MEMORANDUM

UTAH DEPARTMENT OF TRANSPORTATION

SUBJECT: Standards Committee Meeting Minutes and Next Meeting

Figure 1
Pavement Sawing Cost Breakdown

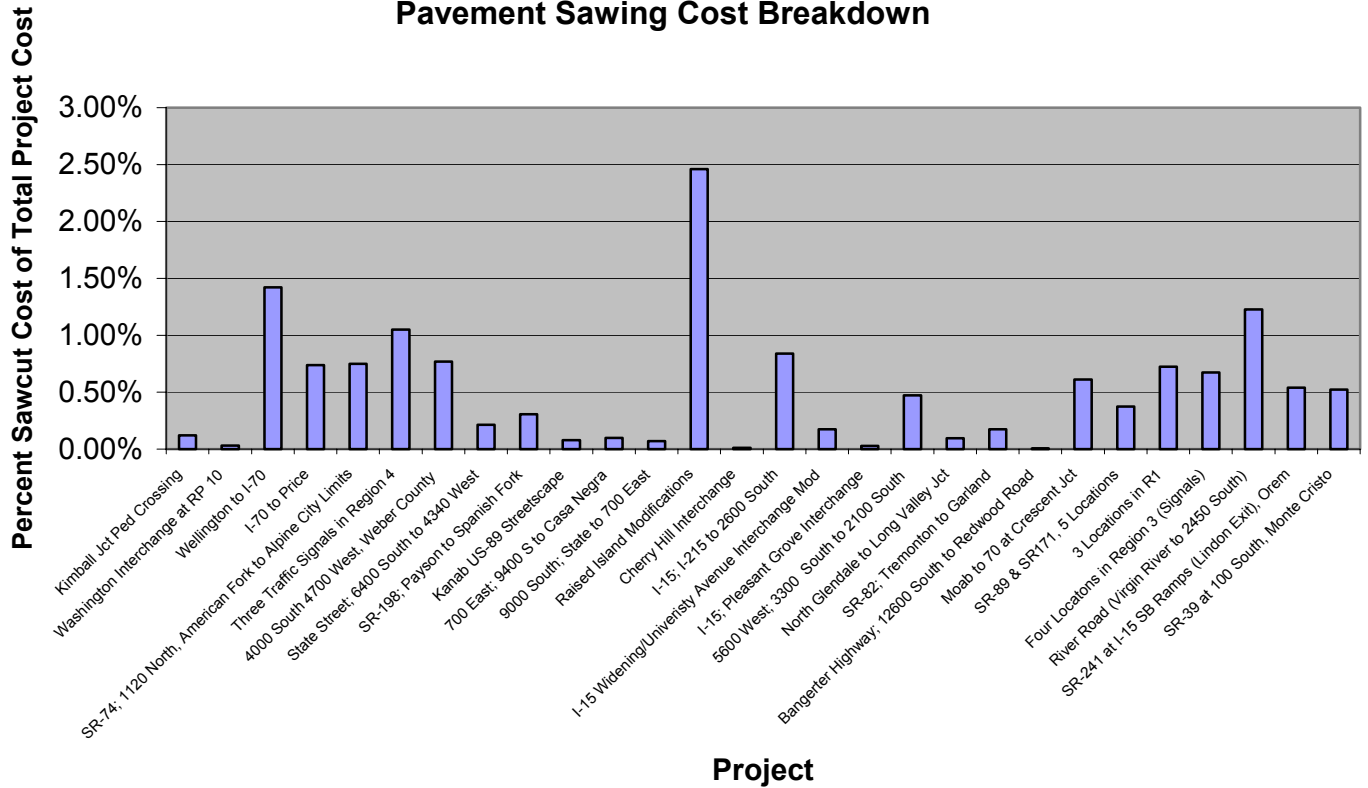
- ☐ First, consider bid item “Asphalt Pavement Sawing” (saw cutting for removal of asphalt pavement). Currently, there are two ways of paying for saw cutting, by the inch-foot and by the foot. For either case our current Measurement and Payment document says “If the average depth exceeds the plan depth by 2 inches or more, the unit price will increase by 20 percent.” If we actually think that we can give the contractor an accurate plan quantity showing asphalt pavement thickness accurate to the nearest 2 inches, we are fooling ourselves. Asphalt pavement depth varies WIDELY. In fact, on an urban job, the pavement thickness for the roadway can vary as much as 12 inches. Even more confusing is the change in thickness as you go from centerline to the edge of the existing asphalt. Pavement thicknesses near centerline tend to be thicker because it has commonly been in place for years and been overlaid multiple times. Pavement thicknesses near the edge of pavement tend to be thinner because developers have commonly installed the pavement. What about change in thickness where utility companies have trenched? How do we estimate the thickness of every asphalt driveway or parking lot? My point is this: trying to estimate an accurate existing asphalt thickness is a futile attempt at best. Callouts for asphalt pavement sawing can take up a good portion of plan sheets. Why should we make designers spend hours calling out, estimating, and detailing asphalt pavement sawing for quantities that we know are wrong?

Bottom line: It simply does not make sense to spend so much time in design and construction planning and documenting saw cutting details given the incidental nature of saw cutting in the overall construction process.
